ABP— 314485-22

An
Bord
Pleanála

Planning Appeal Online Observation

Dublin Airport, Co Dublin

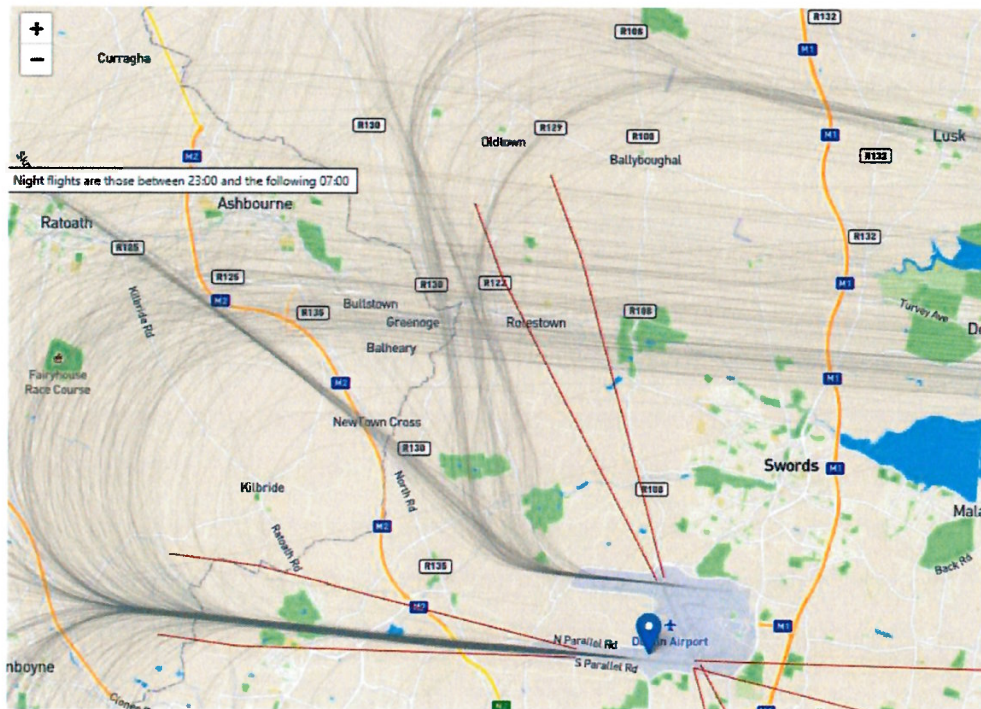
- Flying divergent flight paths on the North Runway for Westerly operations contravening the EIS of 2007
- Divergent flight paths currently in operation do not align with EIAR for this current planning application that is under appeal

- 30-degree divergence was not proposed in the 2016 consultation
- Condition 3 of planning does not allow for dual runway departures under Option 7b
- Flight paths used in Insulation Scheme approved by Fingal County Council in 2016, based on 2007 planning permission, show straight out operations

- Departures on North Runway on August 25-27th and all dates of westerly departures since opening are showing divergent routes contravening the planning permission from 2007
